CITY OF CONWAY, ARKANSAS HISTORIC DISTRICT COMMISSION

October 26, 2026 • 5:30pm • 1111 Main Street

+-Asa P. Robinson Historic District Certificate of Appropriateness Review

NEW, DETACHED GARAGE 1621 Robinson Ave

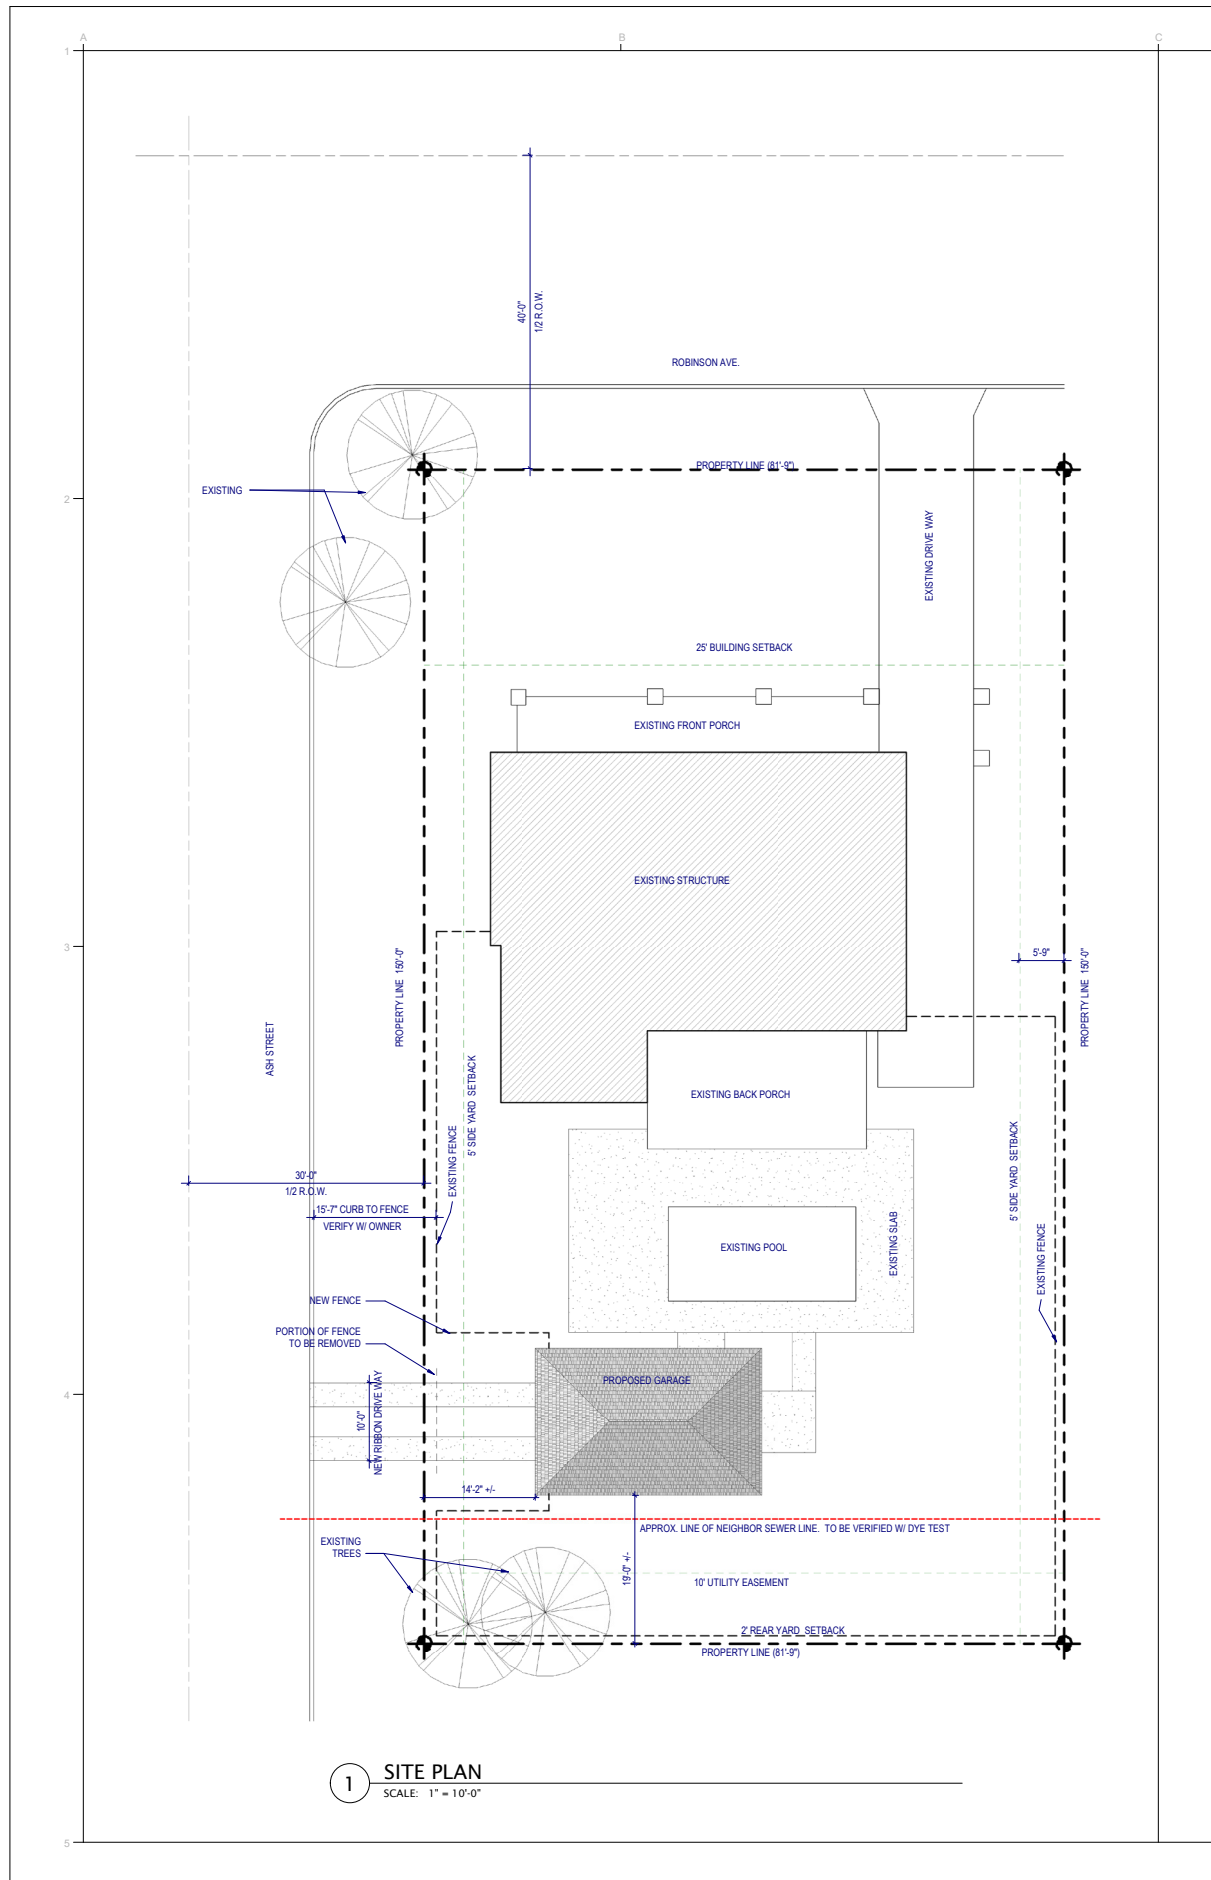
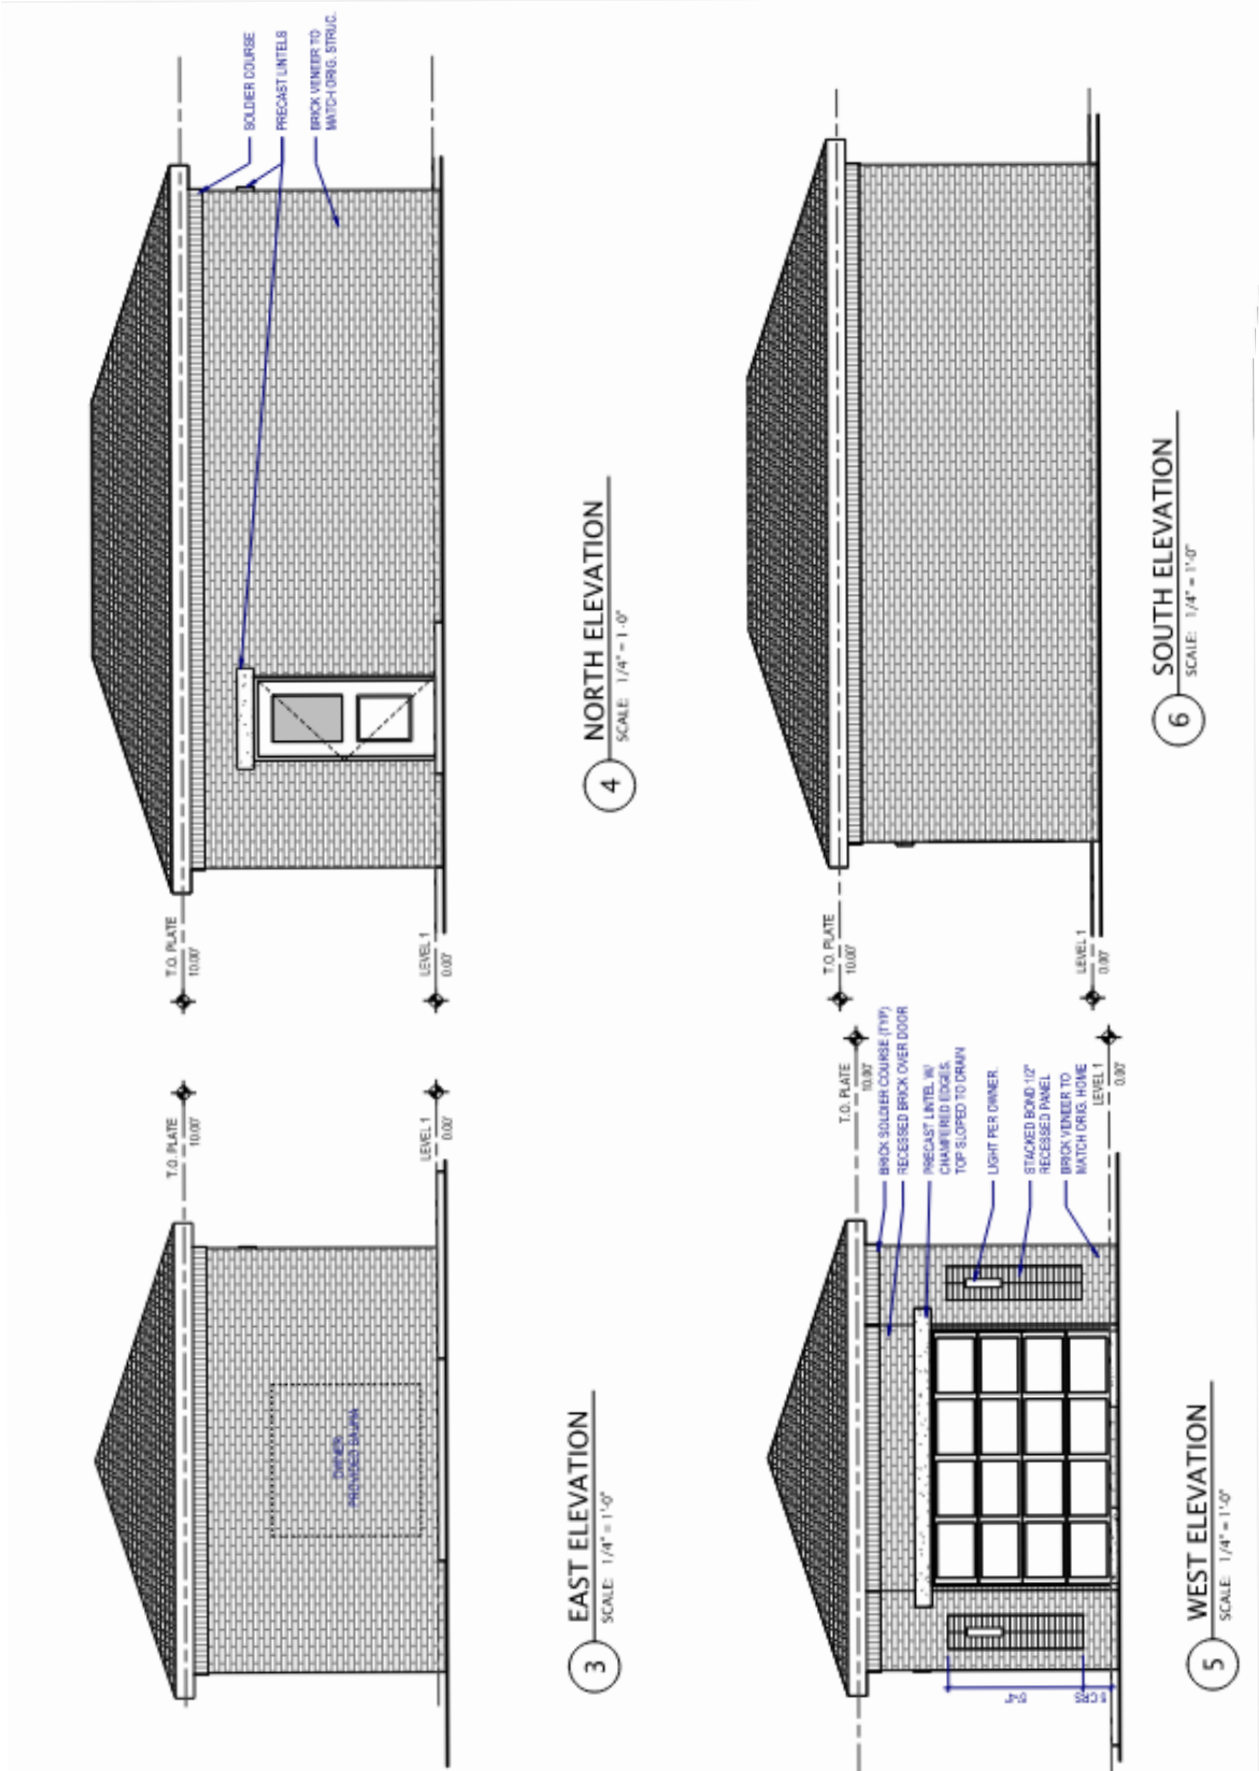
Two shrubs appear to be vulnerable because of this construction but their diameter and proposed status is not specified on the site plan and clarity is required prior to issuance of a Certificate of Appropriateness.

An existing shed will be removed prior to construction of the new garage. The .28acre lot (or 12,196sf) can accommodate 7,318sf of impervious area.

With existing structures, driveways, slabs, pool, etc. 4,699sf is already being consumed. The proposed garage, concrete driveway and walkways will result in a total footprint of 5,299sf or 43%. The accessory building's footprint is 18% of the primary structure's footprint.

1. Applicant must obtain all applicable building permits* if/when a Certificate of Appropriateness is granted.
2. The existing shed must be removed prior to issuance of building permits of the proposed garage.
3. If the existing sidewalk is damaged during construction, it must be repaired.
4. Lighting shall be inward, downward, and shrouded to stay within the bounds of the property.
5. Materials must match those shown on the elevations.
6. Prior to issuance of a Certificate of Appropriateness, the applicant shall submit for review and approval an updated site plan detailing significant trees to be removed and those to remain as well as location of replacement trees, if applicable. Any significant tree removed must be replaced at a 1:1 ratio and the stumps must be removed or ground to the surrounding surface soil level.

1 835 FAULKNER SITE PLAN
SCALE: 1/8" = 1'-0"

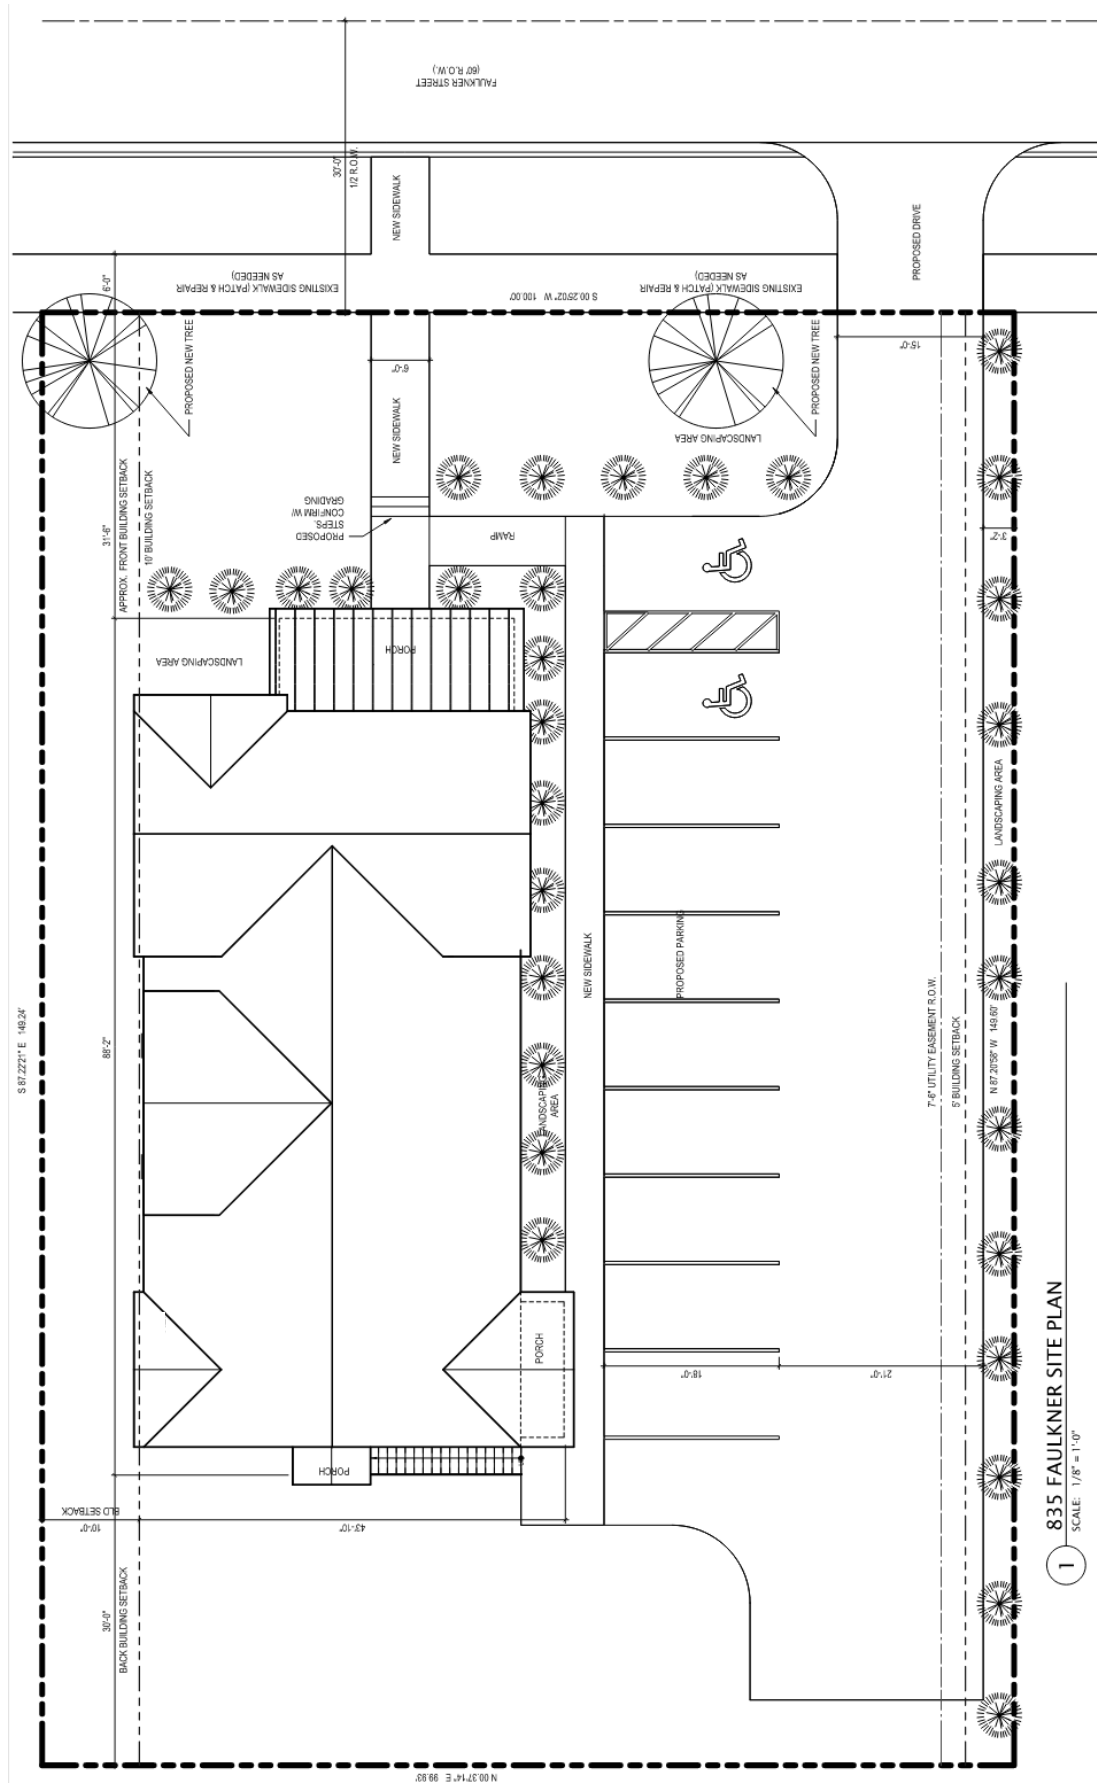
Simulated Divided Light (SDL) windows are proposed. This conflicts with the guidelines. The front door appears to be glass and aluminum. It would benefit from additional ornamentation in the form of an awning or transom with potentially an alternative design more cohesive with the folk Victorian style of the residence.

The lot has 100' of frontage which requires the planting of three trees. Overhead utilities exist along the property frontage necessitating planting understory trees. There are two trees proposed for planting on the site plan with unspecified landscape planting throughout. The type of tree must be specified on the landscape plan submitted for Site Development Review (SDR). A minimum of three trees are required along the frontage and all other landscaping shall conform to landscaping standards as outlined in the Conway Zoning Code for commercial development.

Existing, significant trees over 8" in diameter are not shown on the site plan.

6. The landscape plan submitted for Site Development Review must show trees to be retained.
7. Existing, significant trees over 8" in diameter must be retained. If their removal is necessary, it will require Historic District Commission review.

10. The use of a driveway from Faulkner St may require a variance from the Board of Zoning Adjustment.
11. Windows shall be true divided light with wide trim.

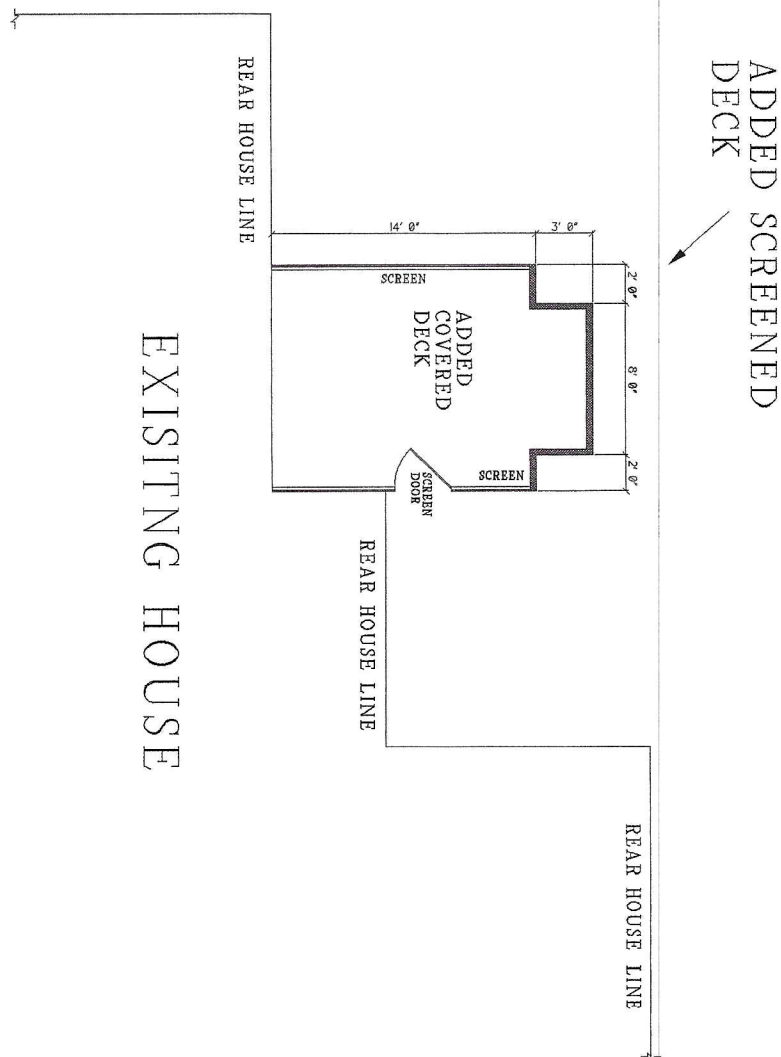
The southern addition is not detailed on the site plan. However, the applicant has stated that it was constructed on an existing slab and that the dimensions did not increase with the covering of the pergola roof. Streetview imagery confirms this assertion.

The applicant has installed tin roofing on the additions. Prior to construction of the additions, tin roofing was present on a dormer facing Hunter St.

- a. An updated site plan specifying the dimensions of the southern porch addition. If the specifications result in any nonconformity with the requirements of OCDOD, the applicant may need to have the project reviewed by the Historic District Commission.
- b. Elevations showing the southern porch addition.

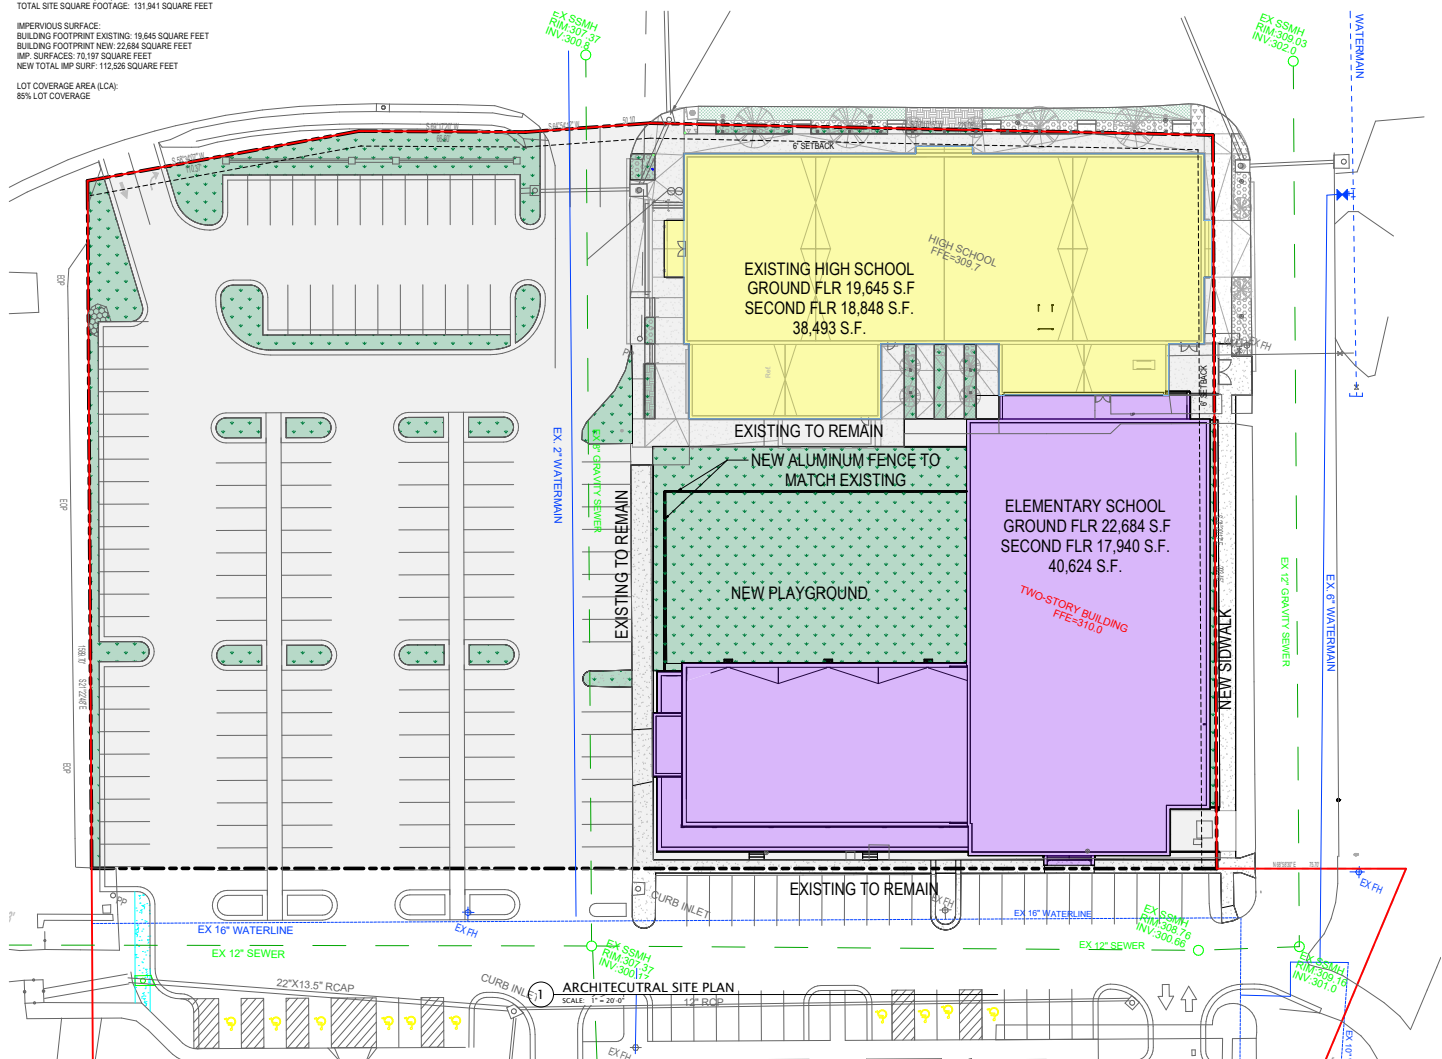
The width of the sidewalk is not specified on the site plan. Existing landscaping along the front of the high school is shown on the site plan, but nothing is proposed for the addition. The project is conditioned to require similar landscaping along the elementary school addition.

Lighting is not shown on the elevations.

1. Applicant must obtain all applicable building permits* if/when a Certificate of Appropriateness is granted.
2. The applicant shall submit for Site Development Review a landscape plan showing understory tree plantings in wells along with other landscaping elements reflective of existing landscaping along the high school, Chestnut St frontage with one tree per every 30 feet of frontage. Landscaping shall also be shown along the southern portion of the building and the parking lot.
3. Screen all rooftop equipment.
4. Any items not addressed through Historic Design Review shall be addressed through Site Development Review and other applicable planning and permitting processes.
